# Access Compliance Report

## Public Rights-of-Way

Intersection ID: 27397	Main Street: ELM_LN	Cross Street: BALLANTYNE_COMMONS_PY	Location: SW
ADA ID: 4365A8390410	Ramp Type: Perp	Initial Pass/Fail: Fail	Overall Compliance: No
Codes/Mitigation Info/Possible Solution		Field Measurements/Component Compliance	
Severity Score: 22.5

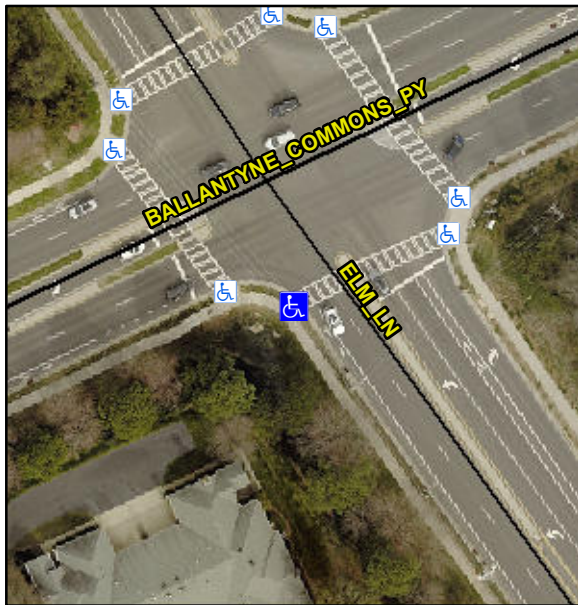
**Not Found, R304.5.1, R304.2.2, R304.5.3**

Compliance	Description	Data	Compliance	Description	Data
N/A	Ramp Length (in)	47.0	No	Ramp Slope (%)	8.9
No	Ramp Width (in)	45.5	No	Ramp XSlope (%)	2.9
N/A	Flare Type LT	N/A	N/A	Flare Type RT	N/A
N/A	Flare Slope LT (%)	N/A	N/A	Flare Slope RT (%)	N/A
N/A	Flare Traversable LT?	N/A	N/A	Flare Traversable RT?	N/A
N/A	Landing Length (in)	N/A	N/A	DWS Provided?	N/A
N/A	Landing Width (in)	N/A	N/A	DWS Contrast?	N/A
N/A	Landing Slope (%)	N/A	N/A	DWS Length (in)	N/A
N/A	Landing X Slope (%)	N/A	N/A	DWS Full Width?	N/A
N/A	Landing Curb? (Y/N)	N/A	N/A	DWS Offset (in)	N/A
N/A	Shared Landing?	N/A			
N/A	Gutter Ponding?	N/A	N/A	Gutter Slope (%)	N/A
N/A	Gutter Lip Ht (in)	N/A	N/A	Gutter X Slope (%)	N/A
N/A	Painted X Walk1?	Yes	N/A	Painted X Walk2?	N/A
	X Walk 1 Direction	To NE		X Walk 2 Direction	N/A
N/A	X Walk 1 Width (in)	106.0	N/A	X Walk 2 Width (in)	N/A
	X Walk 1 Slope (%)	1.7		X Walk 2 Slope (%)	N/A
	X Walk 1 X Slope (%)	0.9		X Walk 2 X Slope (%)	N/A

**Remove & Replace Entire Ramp.**
